Technical Bulletin

Timing belt/kit installation on GM (Isuzu) 1.7D engines

This replaces Technical Bulletin N° 009.

Fig. 3

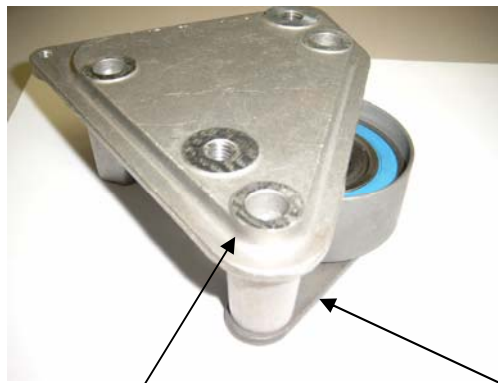
As the initial tensioner base plate was sitting under one of the legs of the engine support bracket (Fig. 3), K015563XS can only be used from engine nr 328704 on.

K025563XS is supplied with a washer to compensate for the shorter leg of the early engine support bracket (Fig. 4), and a stud which is needed to hook the new tensioner spring on (Fig. 5). This K02 can always be used: up to engine nr 328703, using the washer and the stud; and from engine nr 328704 without the washer and the stud.

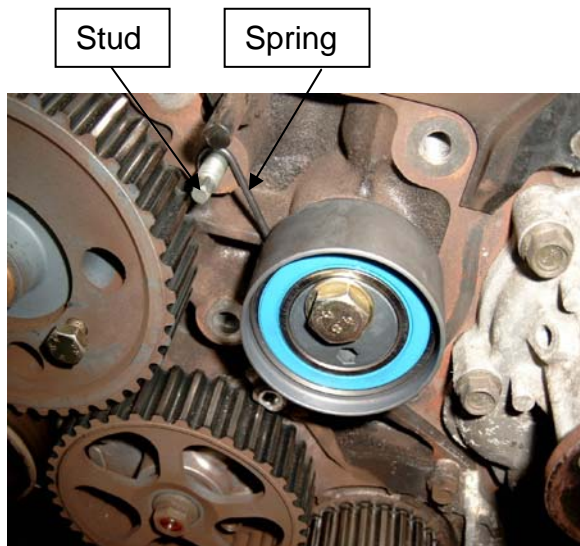
Engine must be cold.

Put engine at Top Dead Centre (TDC).

Block the camshaft pulley (M6 bolt at 8 o'clock) and the injection pump pulley (M8 bolt at 5 o'clock).

Engine has to be supported and engine support bracket taken away.

Fig. 6

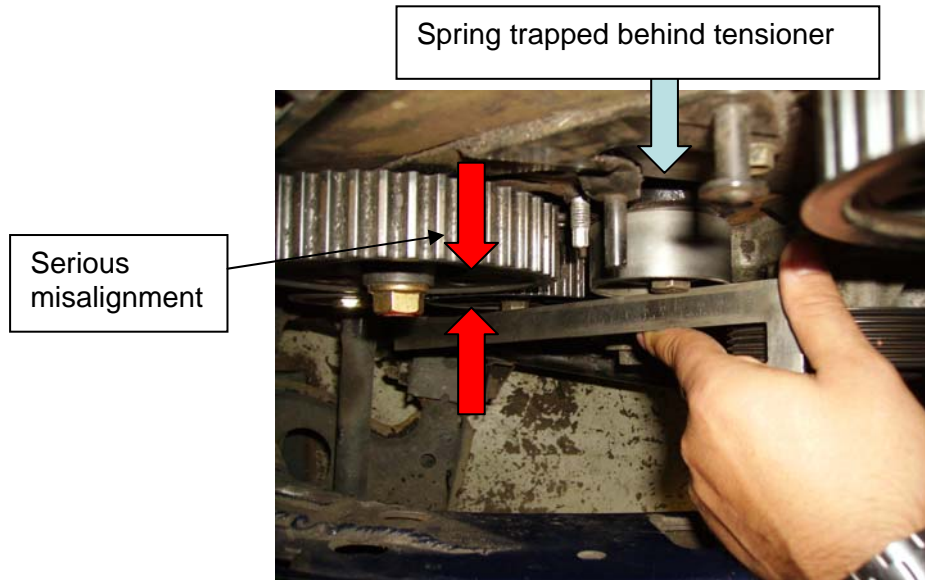
- 4) Install new coil spring tensioner (spring over stud, bolt hand tight); make sure tensioner is sitting perfectly against engine block. If not, the spring could end up between the tensioner and the engine block, creating a serious tensioner misalignment (see Fig. 6)

- 1) Remove old tensioner, spring, idler and belt
- 2) Install new idler and bolt
- 3) Install new coil spring tensioner (spring over stud, bolt hand tight); make sure tensioner is sitting perfectly against engine block. If not, the spring could end up between the tensioner and the engine block, creating a serious tensioner misalignment (see Fig. 6)

Fig. 7

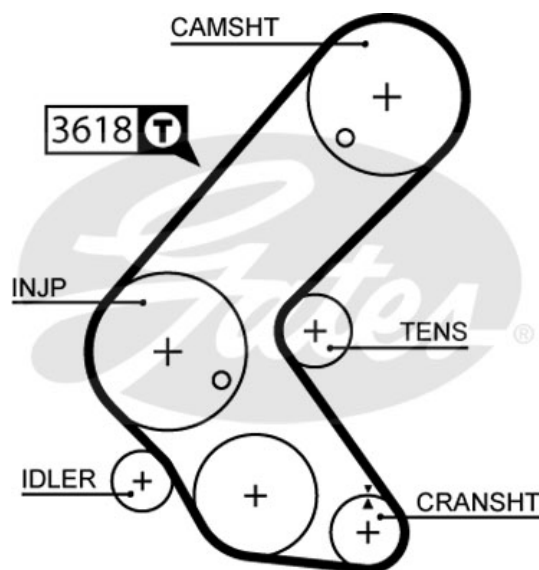
** After completing step 10 of the installation in procedure A), or step 9 in procedure B), it is highly recommended to check the tension in span **T**, (see drive system layout below - Fig. 7) using the Gates Sonic Tension Tester STT-1.

To do this, enter the code 3618 in the STT-1 (ensure chip version 006 is installed) and measure in the normal way. If the tension is too high then the tensioner should be completely released and tensioning procedure repeated until the green light is obtained.

If the tension is too low then it will be necessary to assist the tensioner spring with the Allen key; until the green light is obtained.

Failure to observe this procedure could result in the belt tension being too high leading to an overload of the guide pulley, between the oil pump and injection pump, usually causing the idler pulley to collapse (Fig. 8) and leading to severe engine damage.
